Field Report

The Park Danforth **Project No:** 13-059-00
Portland ME **Field Report No:** 21

Living room windows in Apartment 1209. Other apartments similar (Reference Item 21.4)

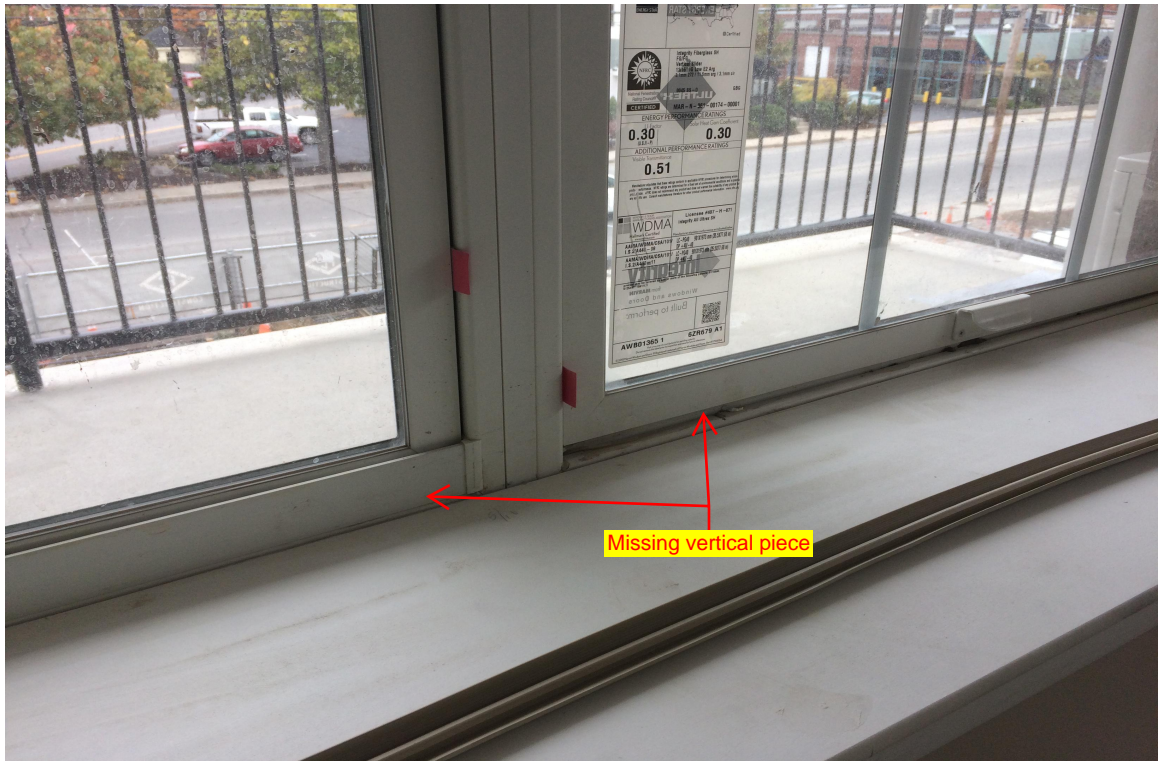
21.4	<p>Resident Apartment Windows</p> <p>Some windows appear to be missing the inside vertical stop. Reference attached photo</p>	Correct Work
21.5	<p>Water Infiltration Admin Suite</p> <p>Water appears to be working its way down to the Admin suite via the level 2 balconies above. Work in place shall be protected from water damage. Any areas exhibiting water damage shall be replaced (See attached photo)</p> <p>Spray fireproofing is missing on the underside of these level 2 balconies.</p>	Correct Work

Canopy Expansion Joint - Reference Item 21.3

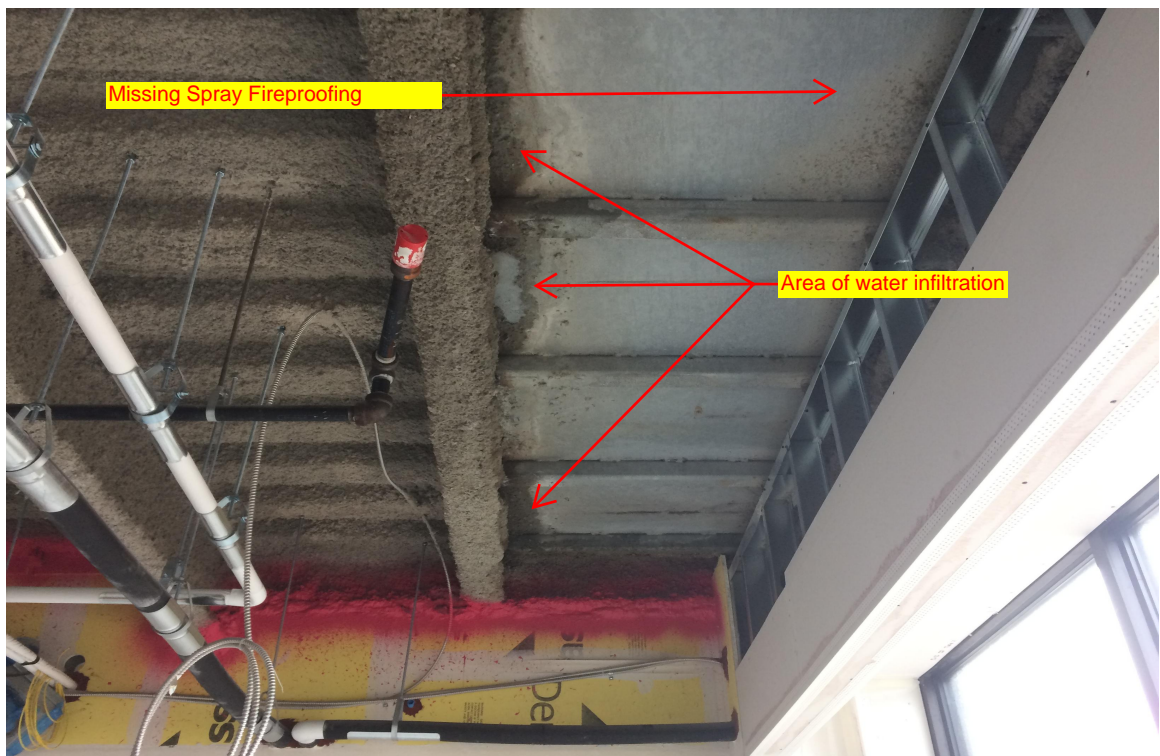
21.2	<p>Level 2 Trash Chutes</p> <p>The recycling door to the level 2 trash chute is incorrectly labeled "Rubbish"</p>	Correct Work
21.3	<p>Connector Canopy Expansion Joint (Courtyard Side)</p> <p>The expansion joint for the connector canopy is missing (Reference attached Photo) Construct in accordance with Sketches issued SI 009</p>	Observation
